***MODIFICATION REQUEST:
Seniors Living Development
34-36 Memorial Avenue, Kellyville***

MP 09_0180 MOD 6

Modifications to Clusters 1 and 5

Secretary's
Environmental Assessment Report
Section 75W of the
Environmental Planning and Assessment Act 1979

Figure 3: Proposed site layout

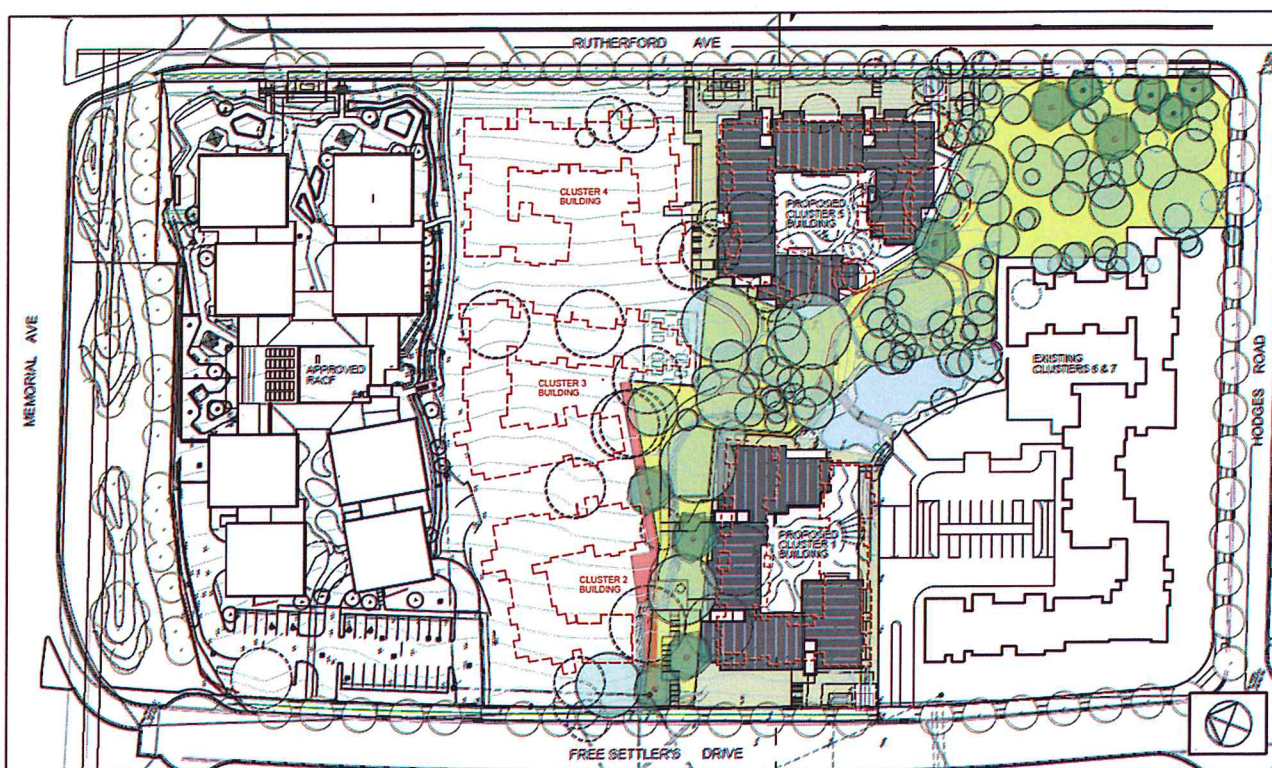
On 17 March 2015, as a result of more detailed design work, the proponent submitted revised plans that reduced the height and modified the building footprint of Cluster 5 as compared to the plans originally submitted notified as part of this modification request. The plans also included reconfiguration of the internal layout and balconies within the Cluster 5. No changes were made to Cluster 1.

The proposed modified layout is depicted in **Figure 3**.

Figure 7: Proposed site plan (yellow area is existing CPW to be retained; red area is proposed additional CPW)

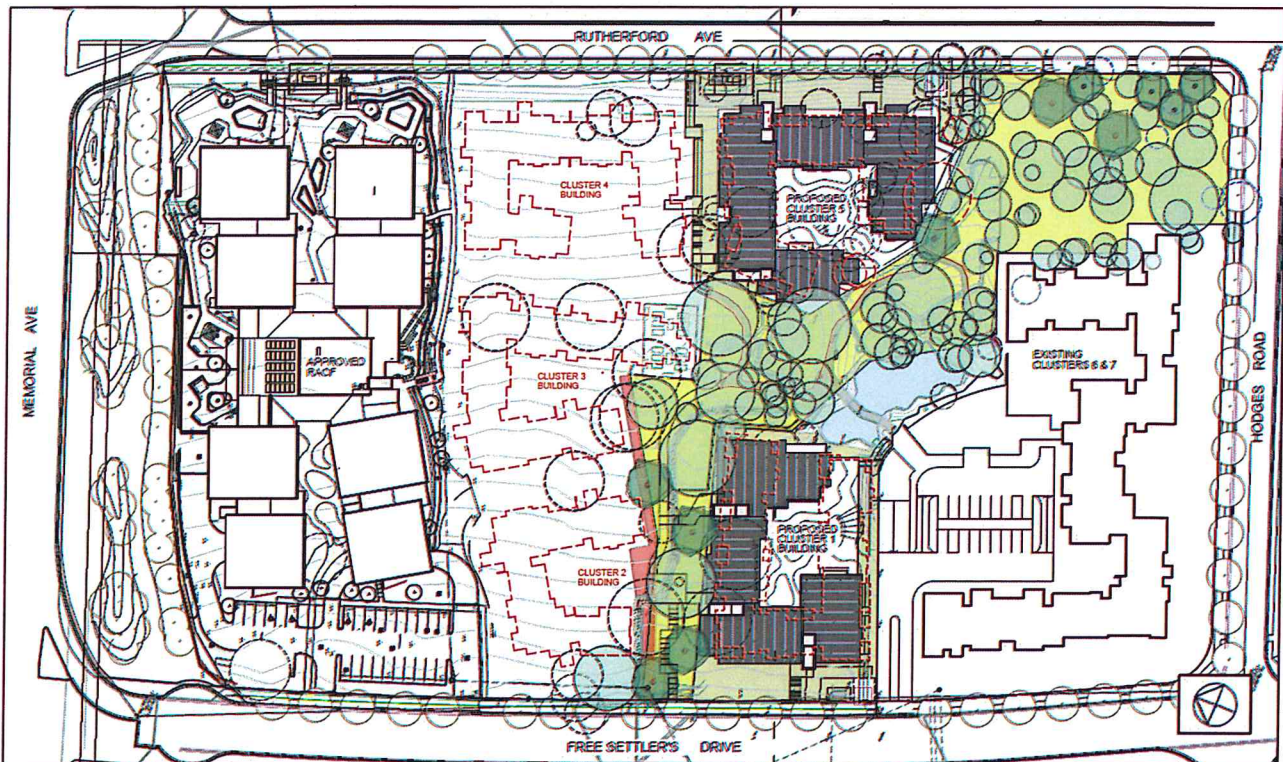
The Section 88B Instrument has been registered. However, the proposed changes to the footprint of Cluster 5, including the access driveway, result in minor amendments to the area designated as retained CPW under the Landscape Restoration Management Plan. Further, four to five *Eucalyptus crebra* trees will need to be removed as a direct result of the proposed amendments. To offset these impacts, an additional 198m² of vegetated CPW is proposed to be provided along the northern edge of the Open Space Park to retain the minimum 0.56ha requirement. An additional 10 new *Eucalyptus crebra* trees are also proposed to be planted (**Figure 7**).

While the loss of CPW should be avoided, the proponent submitted advice from Travers Bushfire and Ecology which support the proposed amendment to the CPW conservation area and replacement of the four to five *Eucalyptus crebra* trees to be removed with 10 new *Eucalyptus crebra*. Travers conclude that this maintains the intent and conditions of the original approval.

The Department notes that the existing approval allows for approximately 70 out of 158 trees on the site to be removed and that the proposal was not a controlled action under the *Environment Protection and Biodiversity Conservation Act 1999*. On this basis, the removal of an additional four to five trees is acceptable given the replacement with 10 trees of the same species and retention of 0.56ha of CPW conservation area, consistent with the original approval.

Given that the proposal will ensure the required minimum area of CPW is retained, and will result in an increase in the number of trees provided in this area, the Department is satisfied that no unacceptable ecological impacts will arise from the proposal.

Figure 8: Typical Floor Plan for Cluster 1

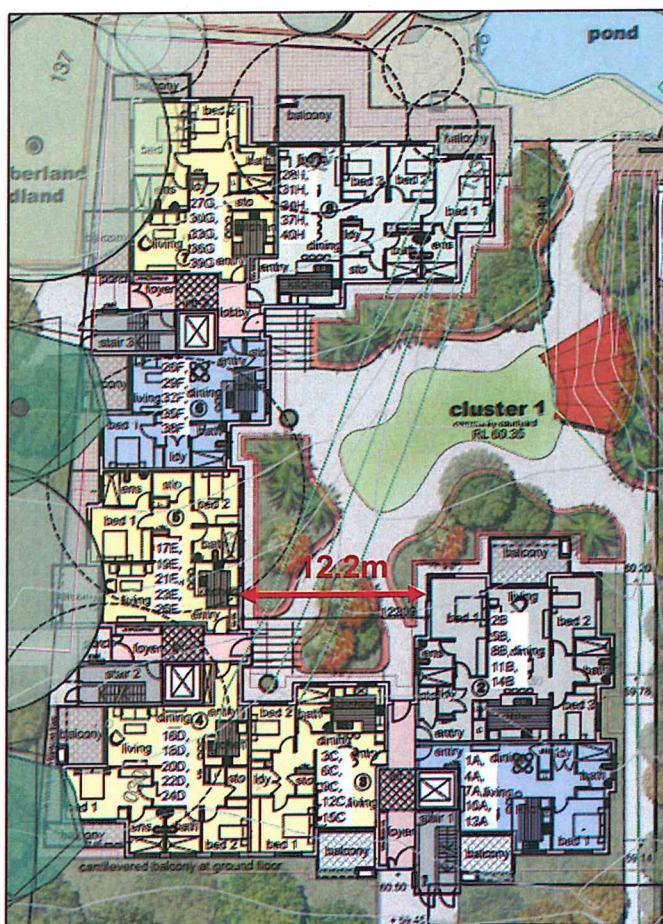
In terms of building separation, the RFDC recommends a minimum building separation of 12 metres for buildings up to 4 storeys in height, and 18 metres separation for buildings of 5 storeys and above. The revised Cluster 1 and 5 buildings generally meet the RFDC guidelines, with the exception of two units on the fifth level of Cluster 1 (**Figure 8**) and reduced separation between Cluster 5 and Cluster 4 (**Figure 9**).

In relation to Cluster 1, two units on the fifth level of the building would be separated from each other by 12.2 metres, less than the 18 metres recommended by the RFDC. However, the window orientation and internal layouts of the dwellings ensures that an acceptable level of privacy will be retained between the two units, which have their primary living areas and open space areas oriented away from each other.

Figure 9: Site plan showing reduced building separation between Clusters 4 and 5

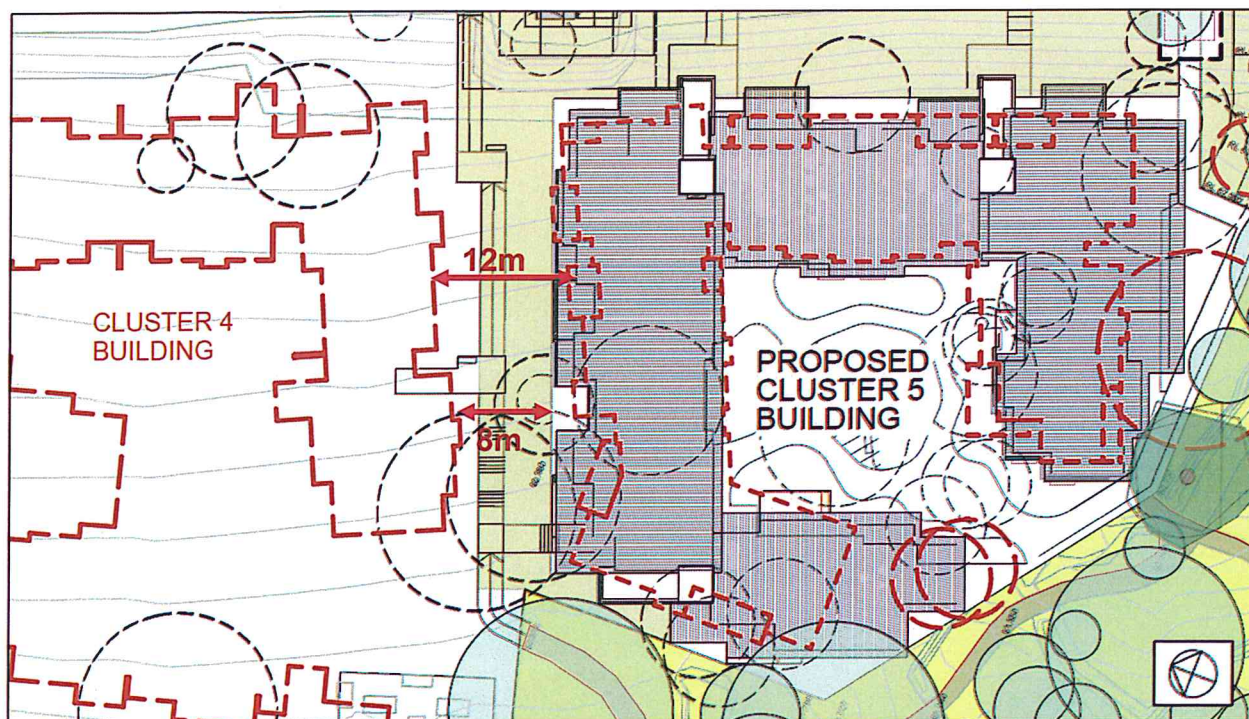
In relation to Clusters 4 and 5, the RFDC recommends 12 metres separation. Habitable rooms and balconies on the northern elevation of Cluster 5 will have a separation of 8 - 12 metres from Cluster 4. Despite having less separation than recommended by the RFDC, an acceptable level of privacy can be achieved between the two buildings as:

- dwellings in Cluster 4 have their primary living rooms and balconies oriented away from Cluster 5. Windows facing towards Cluster 5 are limited to bedrooms, bathrooms and a kitchen window, all of which could be treated to mitigate overlooking impacts (by measures such as increased sill heights or privacy screening); and
- there is sufficient separation to allow dense tree (or hedge) planting between the buildings which will also mitigate privacy impacts. Landscape plans submitted with the modification request incorporate dense tree planting to this area.

A condition is recommended requiring the incorporation of privacy treatments to ensure privacy between the two buildings. With the inclusion of appropriate privacy treatments, the modified proposal would not result in any unacceptable overlooking impacts.
